TO: Design Review Commission
FROM: Sean K. Gallegos, Associate Planner
SUBJECT: SC20-0012 – 148 Doud Drive

Approve design review application SC20-0012 subject to the listed findings and conditions

This is a design review application for a new two-story house. The project includes 2,411 square feet on the first story and 1,464 square feet on the second story. The following table summarizes the project's technical details:

C4: Cedar requested for removal #12

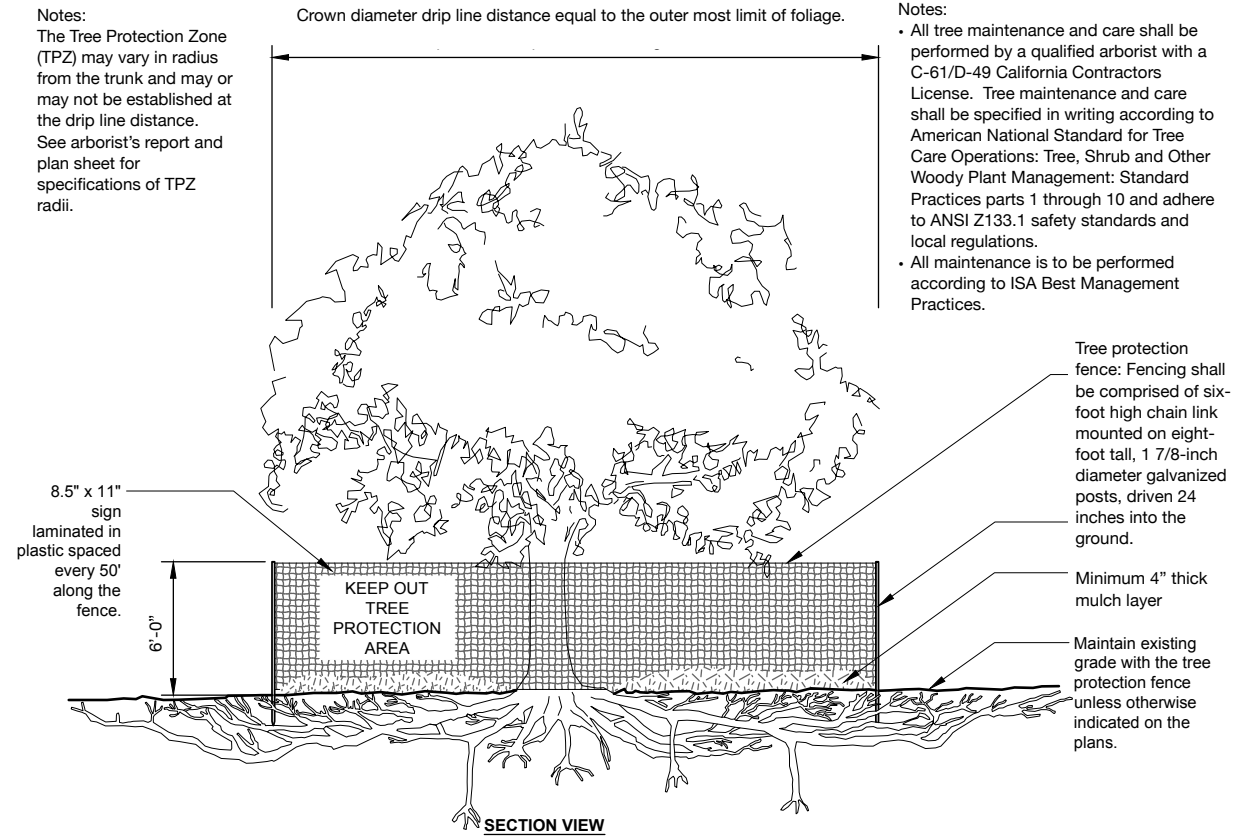
The arborist report recommended the elimination of a deodar cedar tree (no. 12) due to being in poor condition. In reviewing the arborist report, staff found the deodar cedar tree was recommended for removal due to conflicting with proposed improvements. In reviewing the project plans, staff did not find the deodar cedar tree (no. 12) conflicted with proposed improvements due to being 26 feet from the new two-story house. Staff recommends condition no. 3b to preserve tree no. 12.

- a. Update the construction drawings to show the second story window for bedroom no. 2 with an egress window with a sill height of 42 inches.
- b. Update the construction drawings to show the preservation of the deodar cedar tree (no. 12).
- c. Update the construction drawings to show two 15-gallon, Category I or II street trees from the City's Street in the front yard.
